Well Name: JRU APACHE FEDERAL COM	Well Location: T22S / R30E / SEC 24 / NENE / 32.383884 / -103.828921	County or Parish/State: EDDY / NM
Well Number: 707H	Type of Well: OIL WELL	Allottee or Tribe Name:
Lease Number: NMNM89051	Unit or CA Name:	Unit or CA Number:
US Well Number:	Operator: XTO PERMIAN OPERATING LLC

Notice of Intent

Sundry ID: 2839807

Procedure Description: XTO Permian Operating, LLC. respectfully requests approval to make the following changes to the approved APD. Changes to include SHL, KOP, FTP, LTP, BHL, casing design, cement program, mud circulation system and proposed total depth. FROM: TO: SHL: 351' FNL & 1030' FEL OF SECTION 24-T22S-R30E 320' FNL & 950' FEL OF SECTION 24-T22S-R30E KOP: 351' FNL & 1030' FEL OF SECTION 24-T22S-R30E 710' FSL & 330' FEL OF SECTION 13-T22S-R30E FTP: 990' FSL & 330' FEL OF SECTION 13-T22S-R30E 710' FSL & 330' FEL OF SECTION 13-T22S-R30E LTP: 990' FSL & 100' FWL OF SECTION 14-T22S-R30E 710' FSL & 2579' FEL OF SECTION 14-T22S-R30E BHL: 990' FSL & 50' FWL OF SECTION 14-T22S-R30E 710' FSL & 2629' FEL OF SECTION 14-T22S-R30E The proposed total depth is changing from 20696' MD/9736' TVD to 17289.09' MD/9808' TVD XTO Permian Operating, L

[Figure F] 4 String – 2nd Intermediate casing engineered weak point

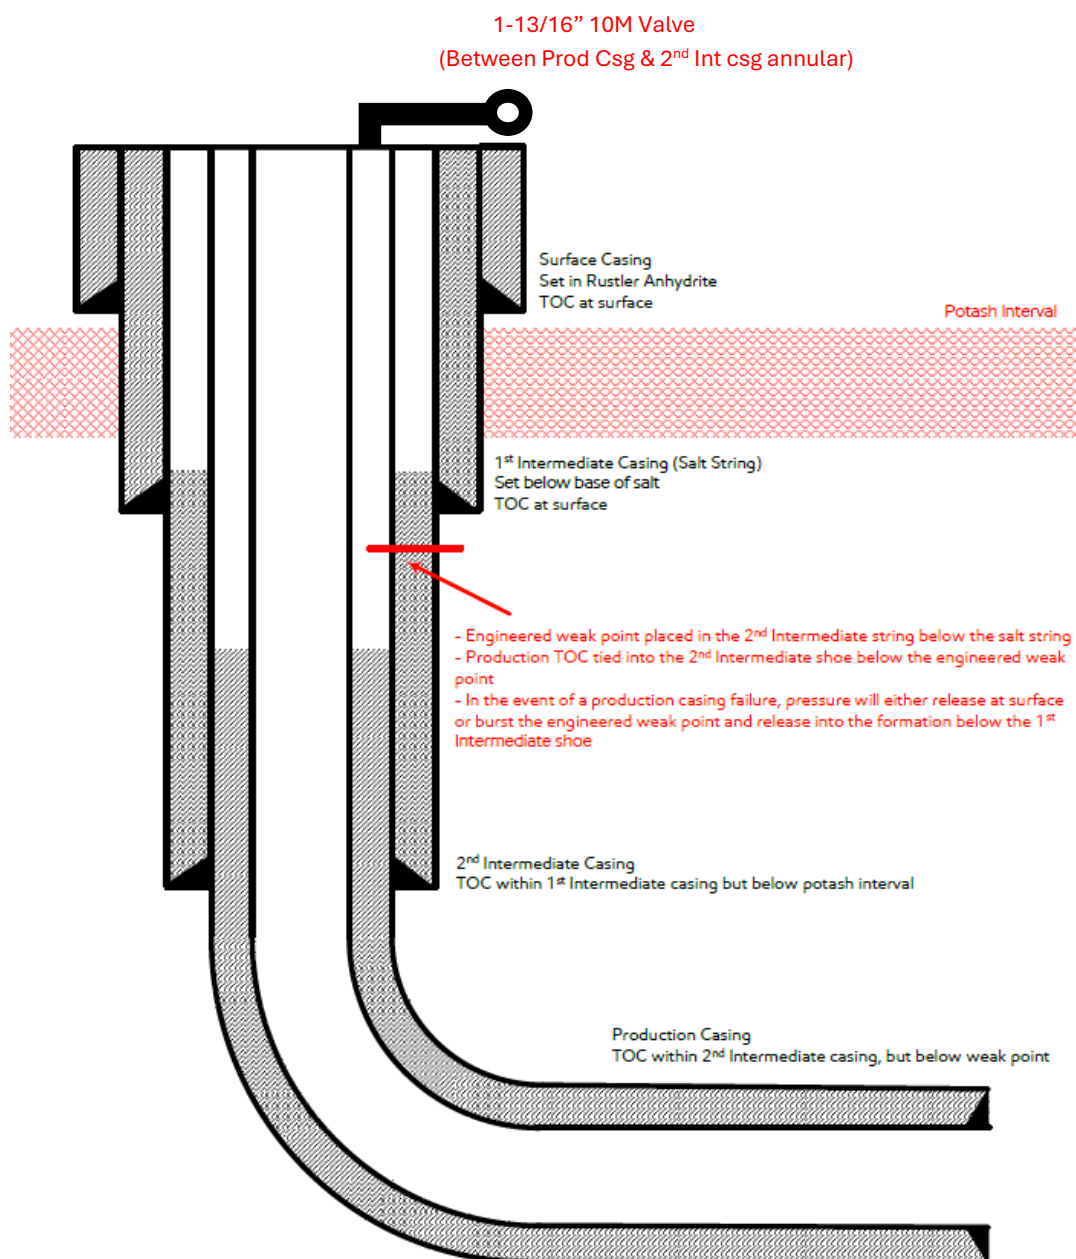
XTO Permian Operating, LLC. respectfully requests permission for a primary and a contingency drilling program for this well. Primary will be a 4-string design with an engineered weak point (R-111-Q: Figure F) & the contingency will be a 3-string design with an open production casing annulus (R-111-Q: Figure B).

Update May 2024:

XTO is aware of R-111-Q update and will comply with these requirements including (but not limited to):

- 1) Alignment with KPLA requirements per schematic below, with engineering weak point casing design and utilizing new casing that meets API standards.
- 2) Contingency plans in place to divert fluids away from salt interval in event of production casing failure.
- 3) Intermediate 2 casing will consist of a primary cement job with TOC at the top of the Brushy Canyon formation within the Delaware Mountain Group.
 - a. Bradenhead squeeze to be completed after primary cement job to tie back TOC to intermediate 1 "Salt string" & below Marker Bed 126 "Potash Interval".
- 4) Production cement to be tied back no less than 500' inside previous casing shoe (intermediate 2 casing) and below the engineered weak point.

Figure B – 3 String Design – Open Production Casing Annulus (Updated May 2024):

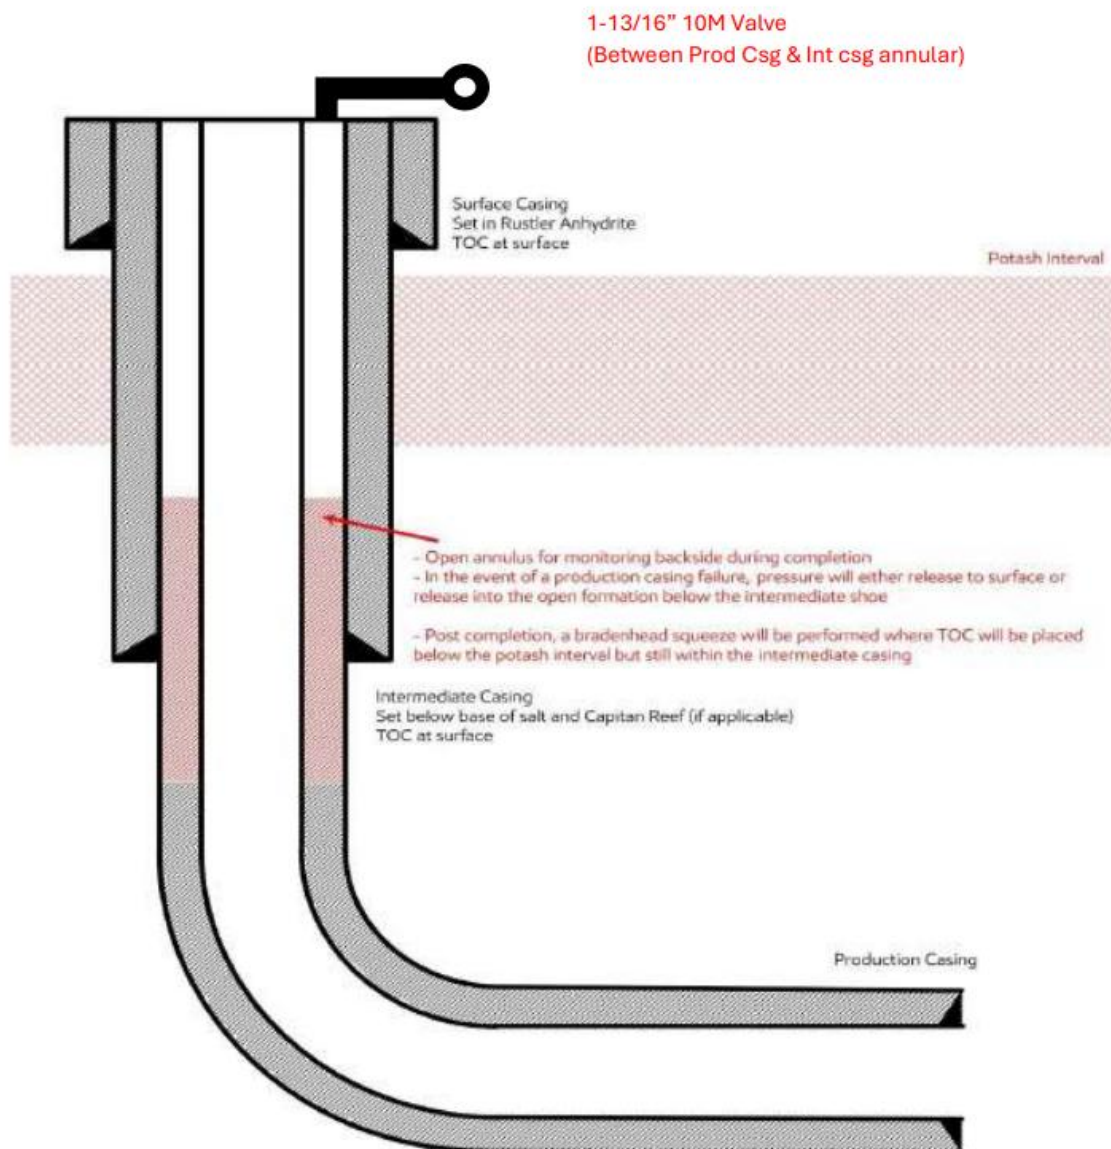
XTO is aware of the R-111-Q update & will comply with these requirements including (but not limited to):

1. Alignment with KPLA requirements per schematic above, leaving open annulus for pressure monitoring during frac and utilizing new casing that meets API standards
2. Contingency plans in place to divert formation fluids away from salt interval in event of production casing failure
3. TOC in the annulus between intermediate & production casing string shall stand uncemented at least 500 feet below the intermediate casing shoe
4. Bradenhead squeeze to be completed within 180 days after hydraulic frac operations have been concluded to ensure at least a 500 feet tie-back has been established inside salt string but with top below MB 126

OPEATOR IS APPROVED TO USE A 3 STRING DESIGN CASING PLAN. ALL R-111Q REQUIRIEMENTS ARE APPLY.
